**General Administration of Civil Aviation of China**

**Comments on KAIB Aircraft Accident Report (Draft)**

**Aviation Safety Committee of CAAC**

Figure 1 Relationship between aircraft crashed site and circling protection area

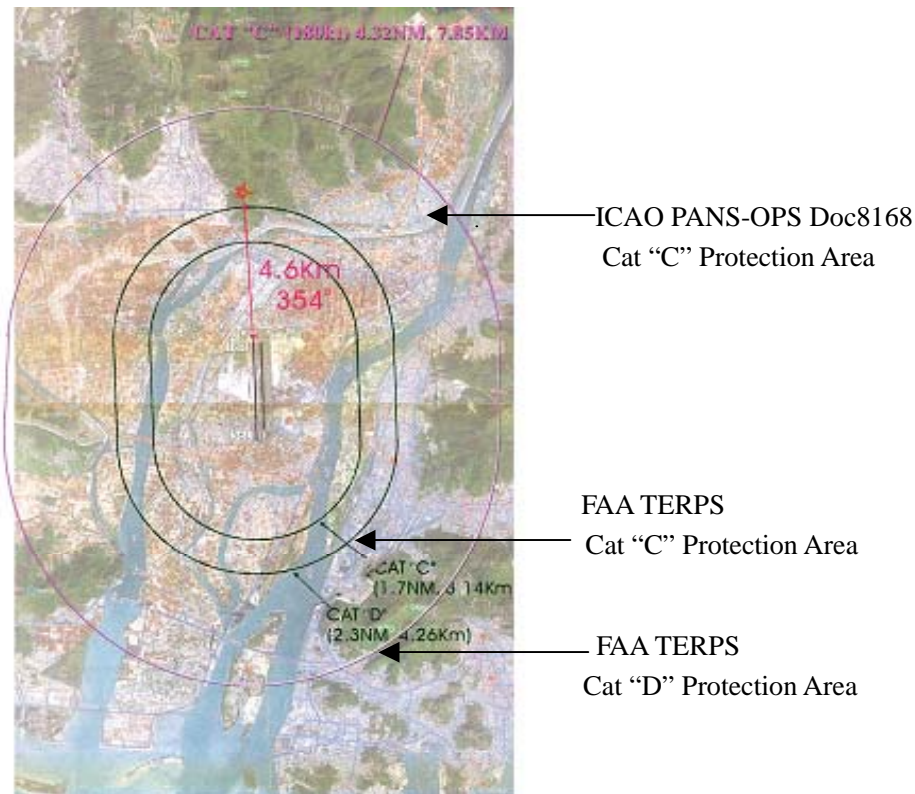
The FAA 《Terminal Instrument Procedure》 (TERPS) standards was used for design the circling procedure of Gimhae Airport, with which the protection area for Category "C" aircraft was 1.7 NM (3.2km) from the runway threshold, the published minimum descend altitude (MDA) was 700ft; And the circling protection area for Category "D" aircraft was 2.3 NM (4.3km) from the runway threshold; the published value of the MDA was 1100ft.

TERPS criteria and ICAO standard (included in 《Procedures for Air Navigation Service-Aircraft Operations》 (PANS-OPS Doc 8168) are greatly different in the design of circling protection area. The protection area of the former is far smaller than that of the latter. Should the ICAO standard be applied, the circling protection area for Category "C" aircraft would be 4.23 NM (7.85km) from the runway threshold; MDA would be 2400 feet.

The aircraft crashed at a point 4.6 km form the runway threshold with true azimuth of 354°, which was outside TERPS Category "D" protection area but inside ICAO PANS-OPS Category "C" protection area.

It is difficult for pilots and controllers to understand and distinguish the difference between these two criteria, particularly when the two criteria are applied simultaneously in one country without a clear and definite explanation.
